Project Owner:	Shelby Public Schools
Project Name:	New Elementary Technology Systems
Issue Date:	November 14, 2022

PROJECT QUESTIONS AND ANSWERS

*This document provides answers to questions asked by bidders who have reviewed the **Technology Request for Bid** for the above referenced project.*

SITE ELECTRICAL PLAN
1" = 80'-0"

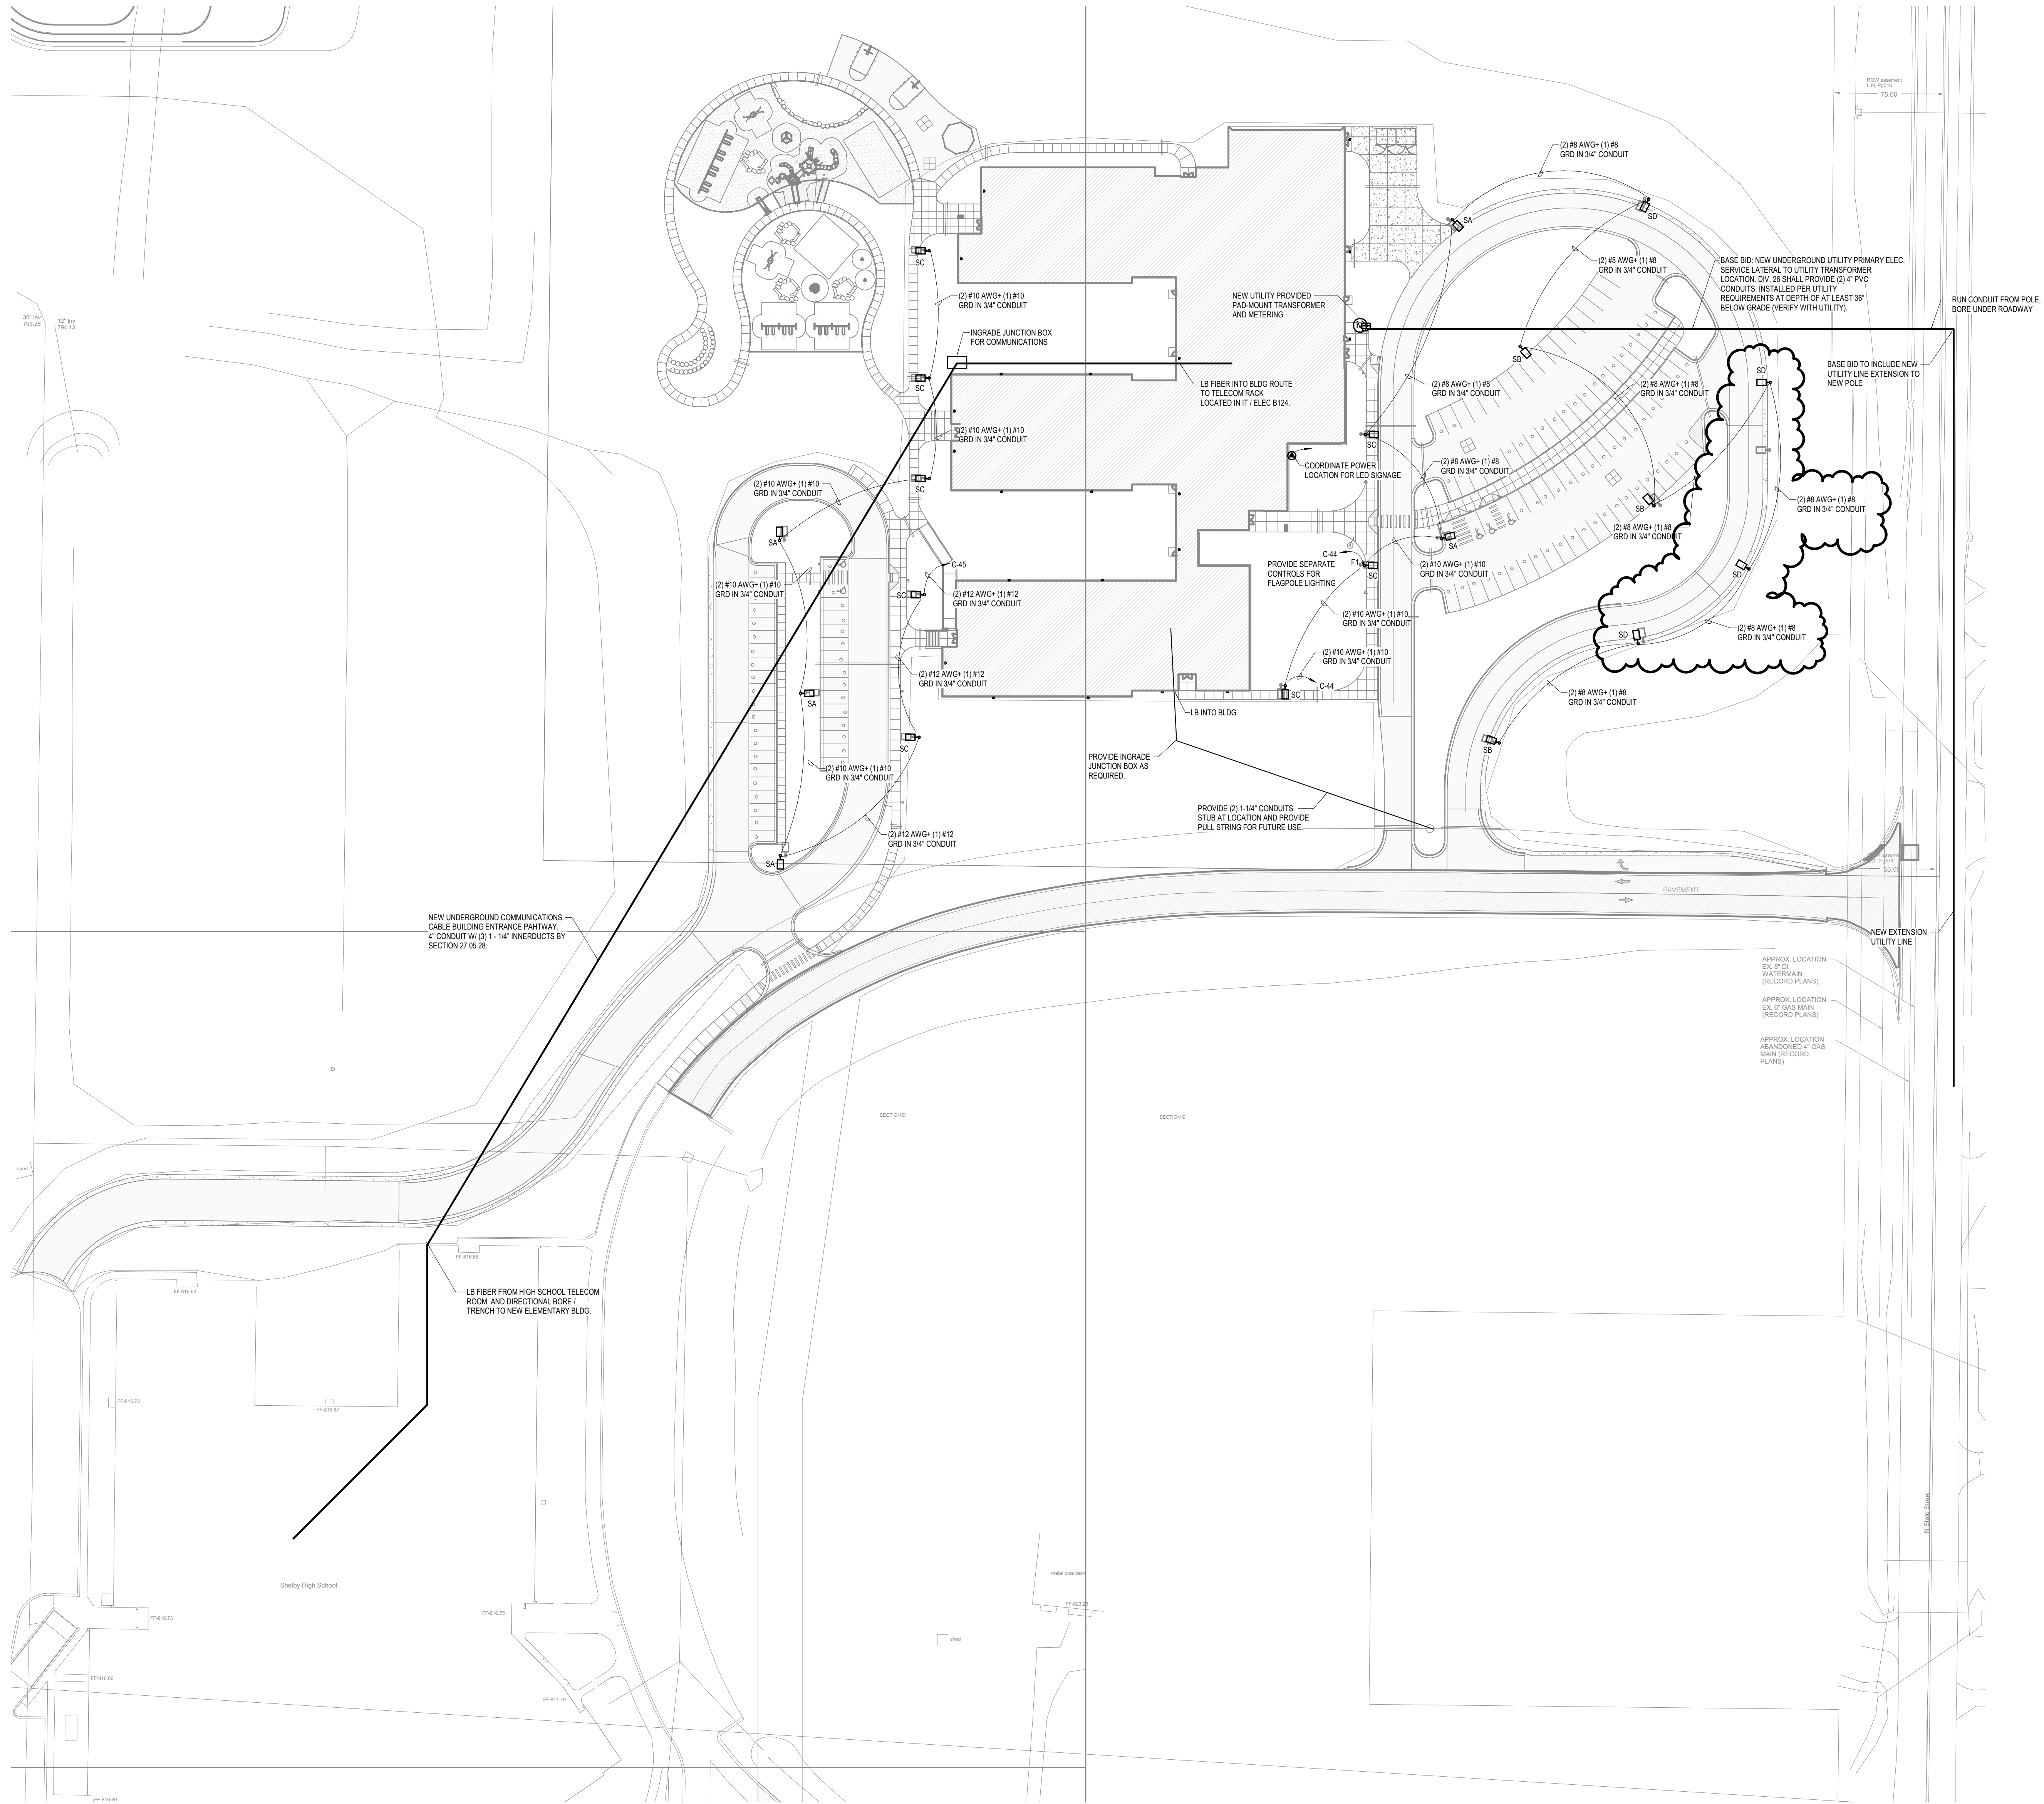
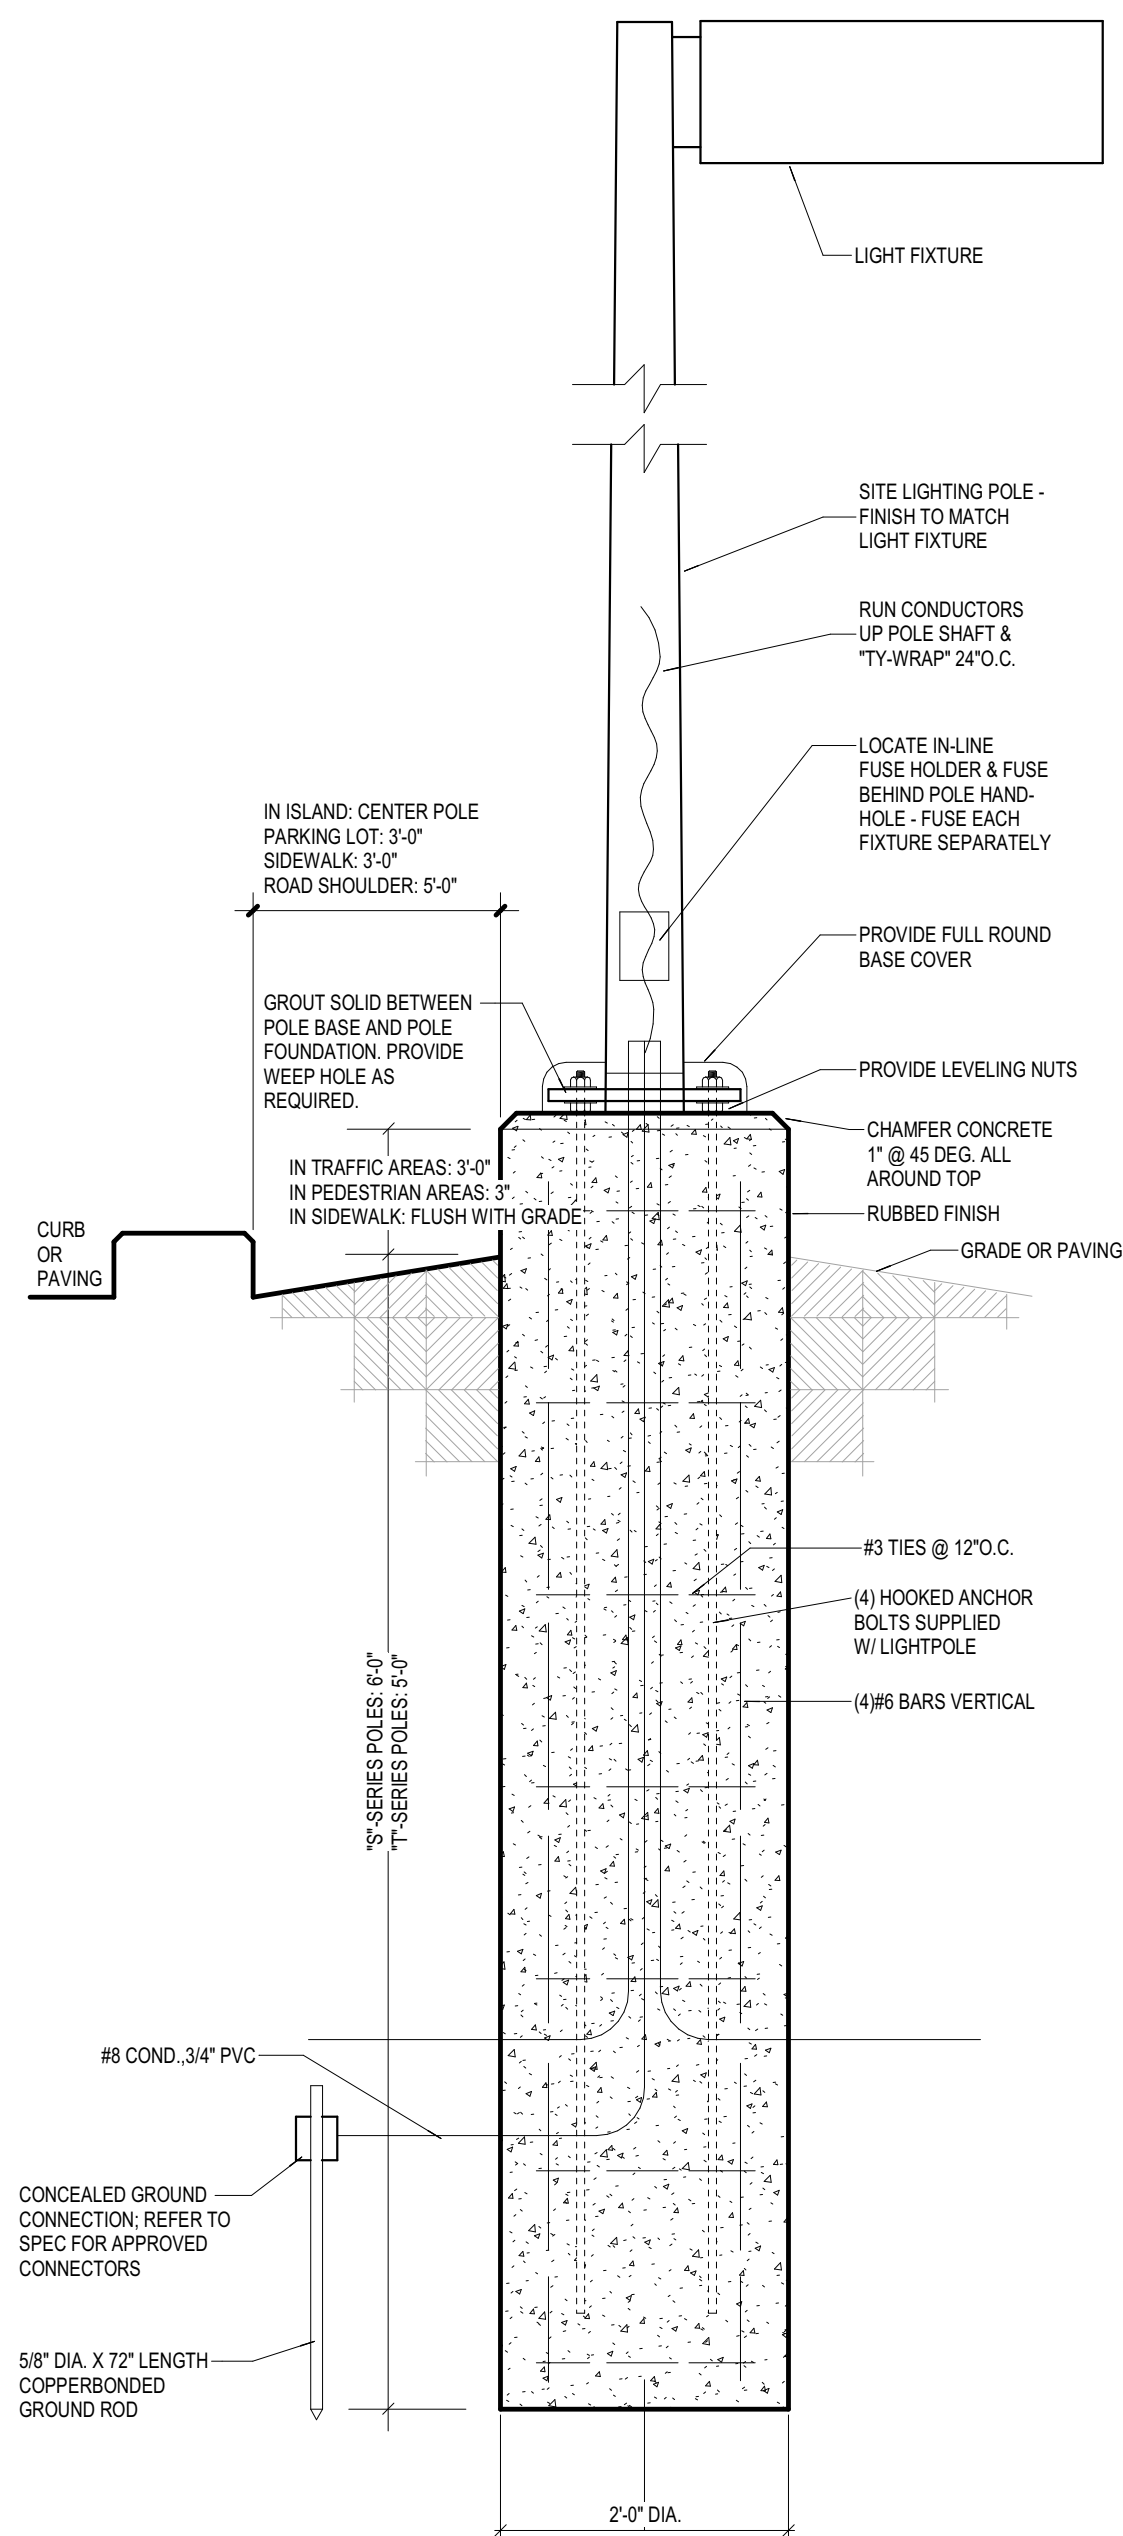
Q7: Will there be a print for the outdoor pathway?

Q12: I do not see any print showing the fiber path between schools as was stated at the pre-bid. At least not in the original bid-pack. Can said print be provided

A: Please see the attached drawing: Site Electrical Plan.

A: Please see the attached drawing: Site Electrical Plan.
